Form C-103
Revised August 1, 2011

| 7. Lease Name or Unit Agreement Name South Hobbs (G/SA) Unit |
| 8. Well Number: 151 |

SHU 151 Proposed Wellbore Diagram (after P&A)

SHU 151 Current Wellbore Diagram (as of July 2018)

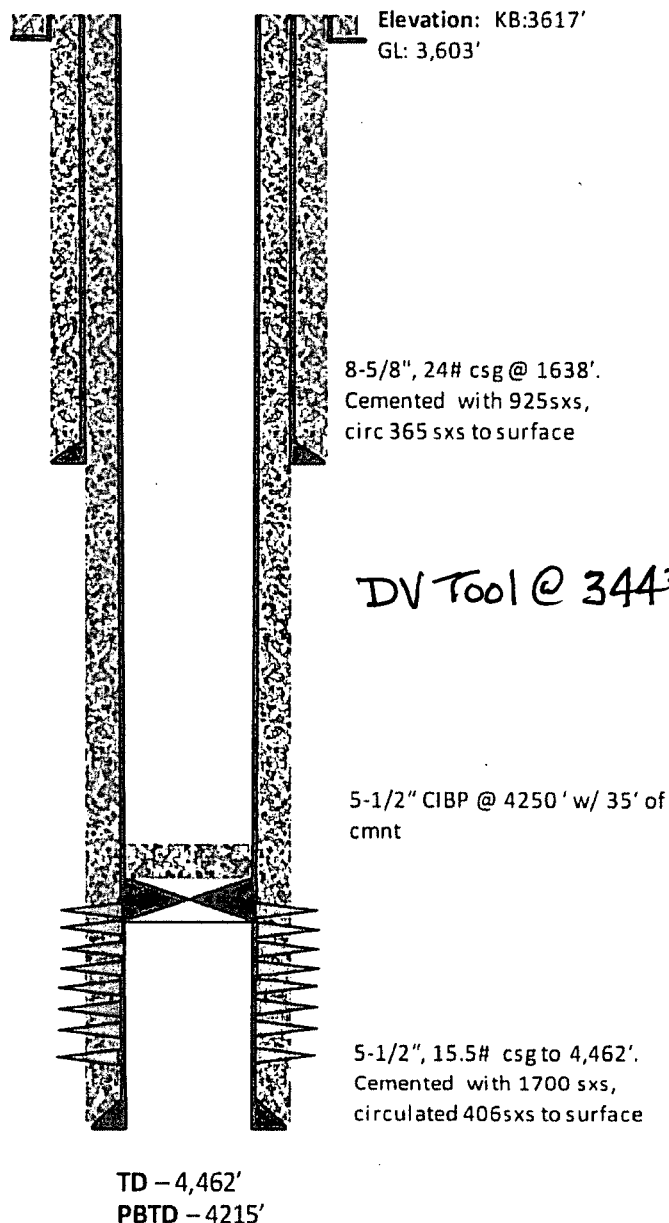
*Circulate MLF
DV Tool @ 3443'
SPOT 25SX from 3493' - 3293' WOC & TAG*
